PRODUCT UPDATE MEMO

SEMICONDUCTOR COMPONENTS

Select Bourns® Semiconductor Components *Change to Country of Origin*

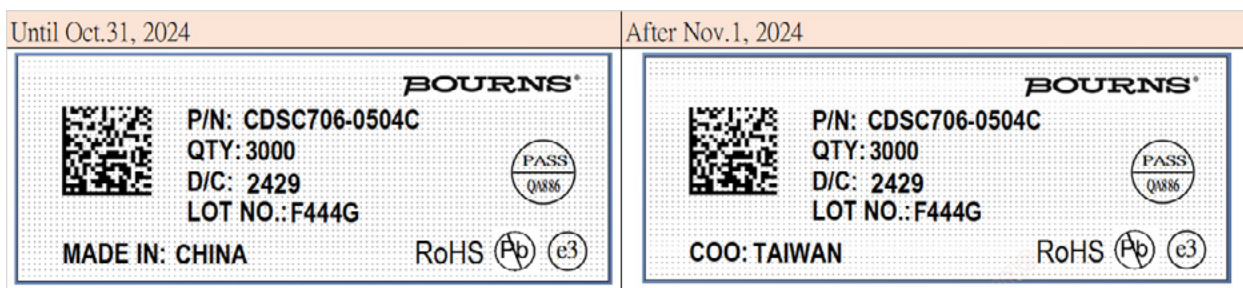
Below, please find an example of how the label will change to clearly show country of origin as “COO Taiwan” and place of final assembly as “Assembled in China.”
